**Correspondence Between
Staff and Applicant
Approval Letter**

21-DR-2017

Case Reference No: 21-DR-2017 Scottsdale Quarter - Block L

RE: 21-DR-2017
Scottsdale Quarter - Block L

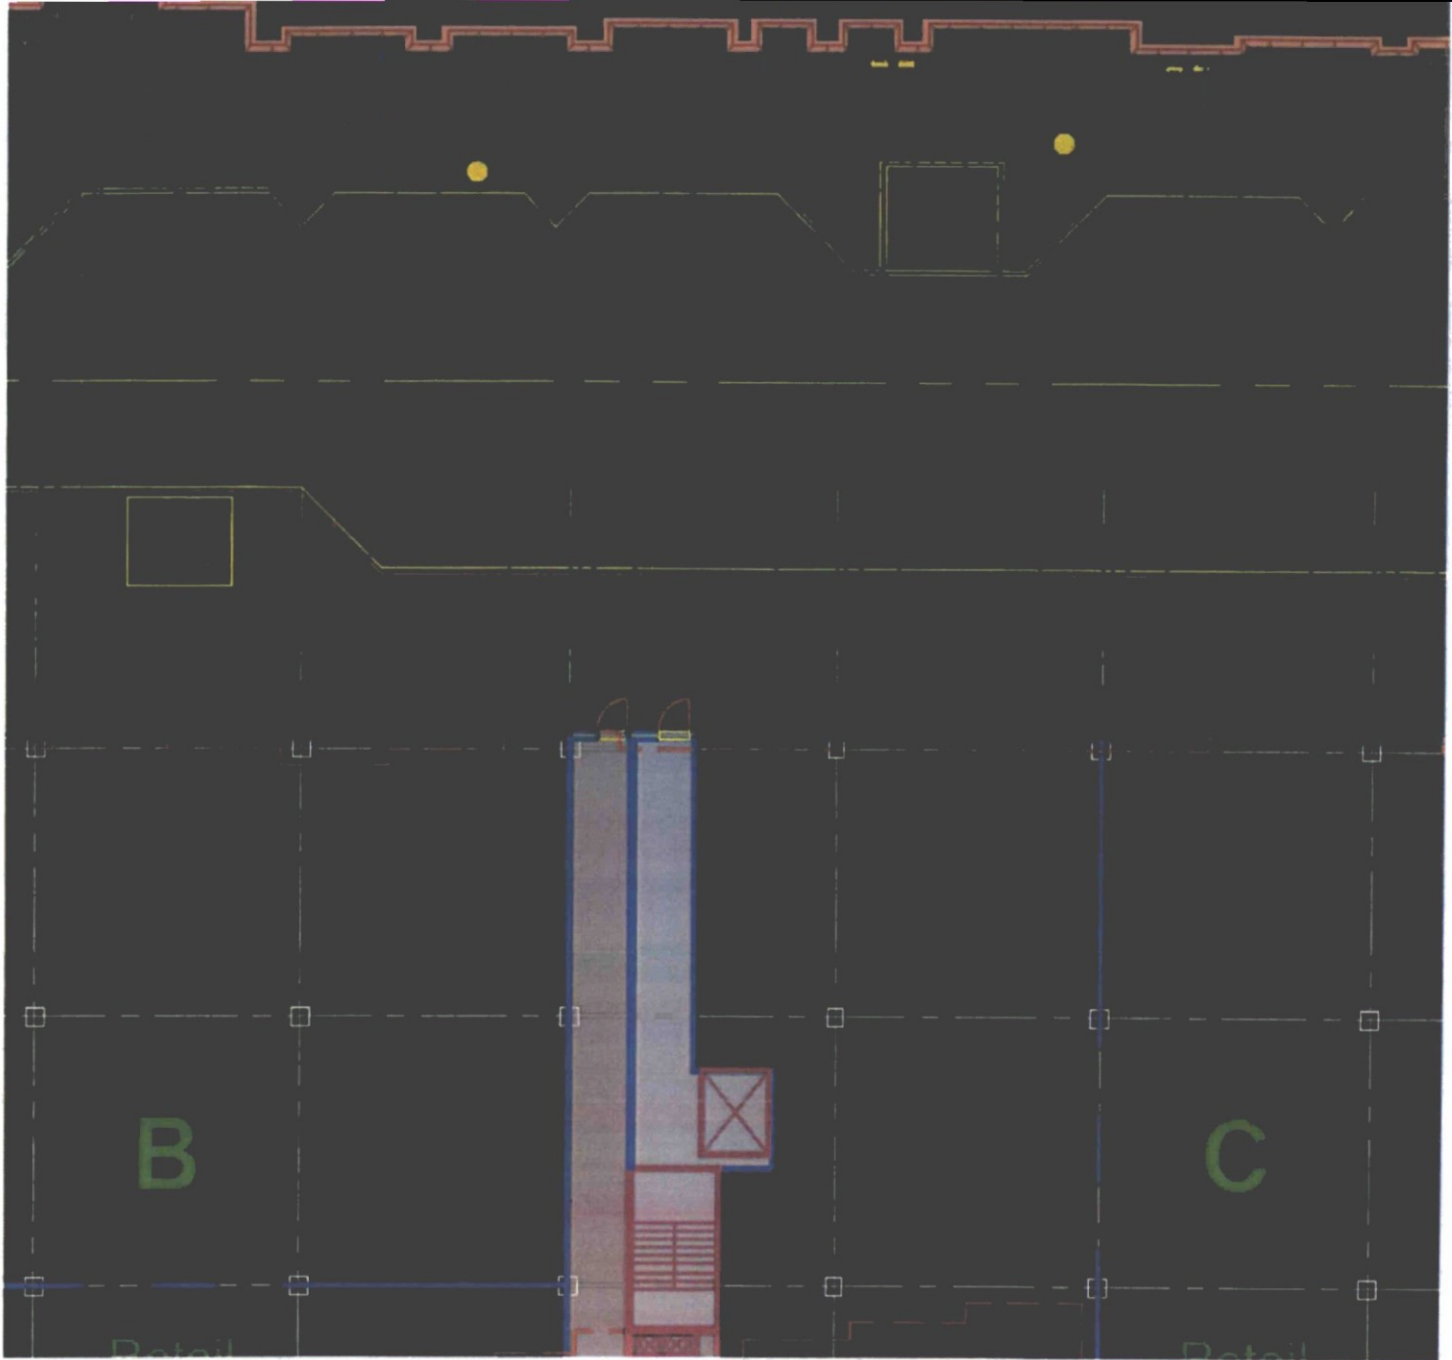
The figure below is the condition between block K (Crescent) on the right, and block L on the left. The dashed blue arcs are the 25' and 49' radius'.
